**Voluntary Emission Reductions in Rice Management Systems v1.0 and  
Regional Calibration Modules  
Errata & Clarification  
September 2016**

This is a supplemental document to the ACR Methodology *Voluntary Emission Reductions in Rice Management Systems*, v1.0 and its Regional Calibration Modules. The ACR Methodology *Voluntary Emission Reductions in Rice Management Systems* v1.0, and all subsequent versions of this methodology, is considered the “Parent Methodology” for both the Midsouth and California modules.

Figure 1. Flow chart of Crediting Period, Project Renewal and Baseline Update.

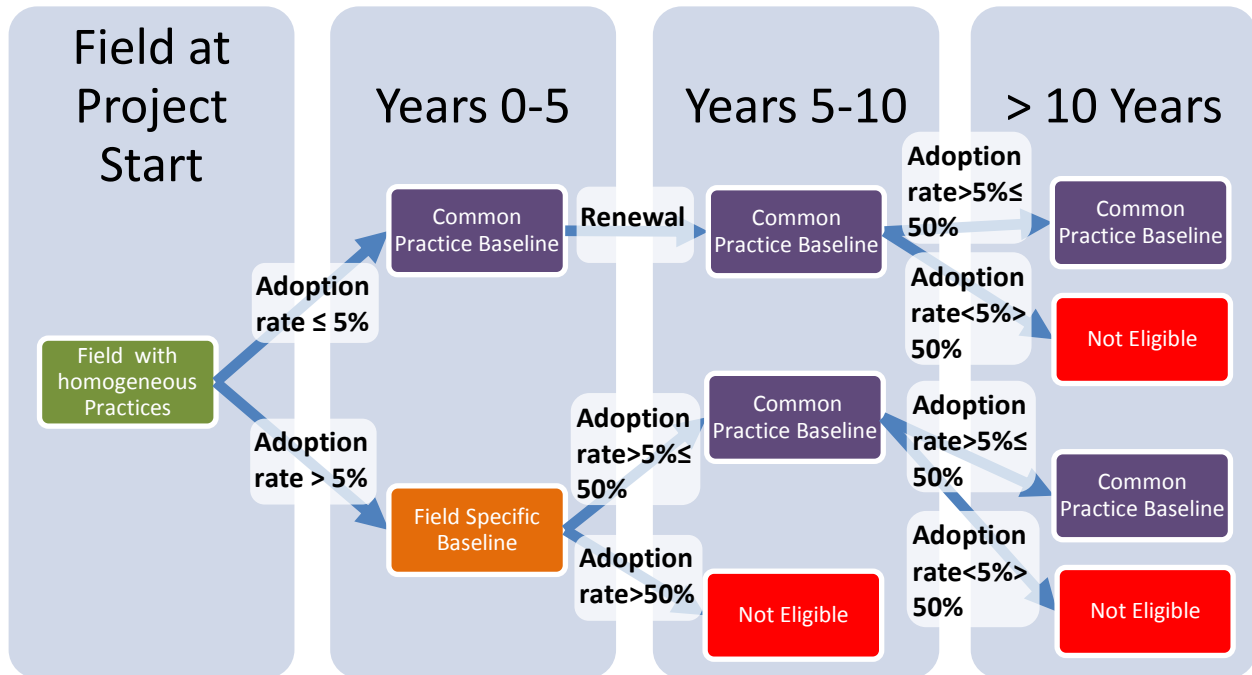
In the parent methodology, “Baseline adoption rate” refers to the baseline adoption rate of the project activities. When a Project Activity is implemented on less than 50% of the acres in the Rice Growing Region, it is considered a practice that is not commonly used, and is therefore eligible for a Common Practice Baseline after year ten. The flow chart is provided to better explain the different baselines allowed. Adoption rates of a specific practice are assessed on an annual basis. At validation of an initial Crediting Period, one annual adoption rate in the past five years suffices to set the baseline adoption rate. However, upon renewal of a project’s Crediting Period the baseline adoption rate must be set as

the average of at least two adoption rates in the five years preceding the Crediting Period. Often little data is available for a given practice initially at project start, but the practice is adopted more readily over time.
